Project: IEEE P802.15 Working Group for Wireless Personal Area Networks (WPANs)

Submission Title: Higher Order APSK Constellations Implementation - Required Edits

Date Submitted: 04 May 2022

IEEE P802.15.3ma Proposal Follow-up: Higher Order APSK Constellations Implementation – Required Edits

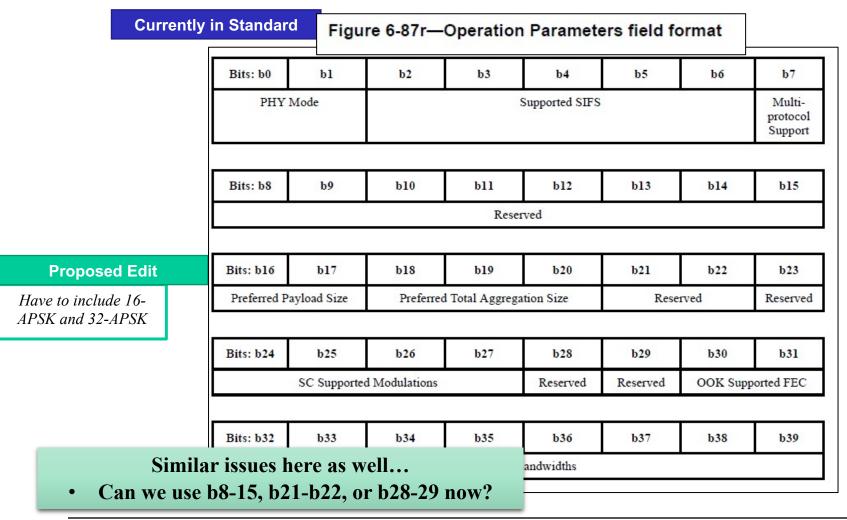
Cı	ırrent	ly in Standaı						_					
		Figure 6-870—PRC Capability field format											
		Bits: b16	b1 7	b18	b19	b20	b21	b22	b23				
		Preferred Pa	yload Size	Preferred	Total Aggre	Supported Subframe I		Pilot Symbol Capable					
		Bits: b24	b25	b26	b27	b28	b28 b29		b31				
			SC Supported M	100000	027	Reserved	Reserved	D30	Supported FEC				
	Prop	oosed Edit											
			Н	ave to inclu	de 16-AP	SK and 32-2	4 <i>PSK</i>

Decision for Discussion (same as before):

- We could add two additional bits
 - There are the same 2 reserved bits later in the field (b28 & b29). (Is this what they were reserved for?)
- Make it mandatory to support the 8-PSK modulation (only solves half the problem)
- Other ideas…?

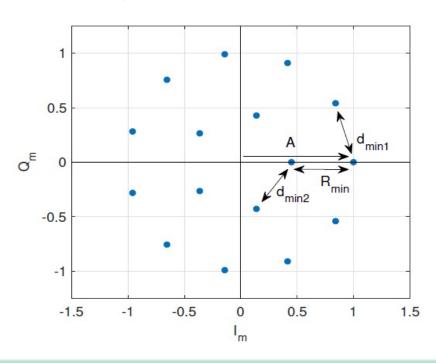
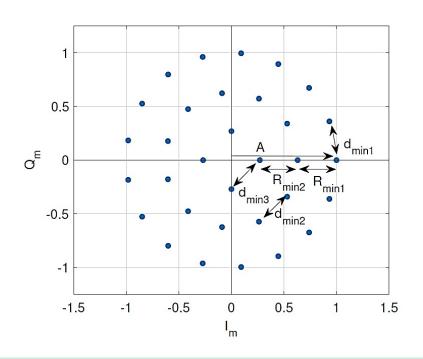
The constellation diagrams of $\pi/2$ 8-APSK, 16-APSK, and 32-APSK are shown in Figure 13-3, Figure 13-4, and 13-5 respectively.

The normalization factors for $\pi/2$ QPSK, $\pi/2$ 8-PSK, $\pi/2$ 8-APSK, 16-APSK, 32-APSK, 16-QAM 64-QAM are 1, 1, $\sqrt{2}/\sqrt{11}$, _____, 1/ $\sqrt{10}$, and 1/ $\sqrt{42}$ respectively.

Questions for the Group:

Why do you specify 3 bits per symbol? What do you mean by the input bit d1? Also are the parenthesis around sqrt(10) intentional?

Insert Figures 12-4 and 13-5

• Would we like to standardize the 3-ring or the 2-ring 32-APSK or both? (I think 3-ring to help with phase noise, but we can also see how the simulations perform)
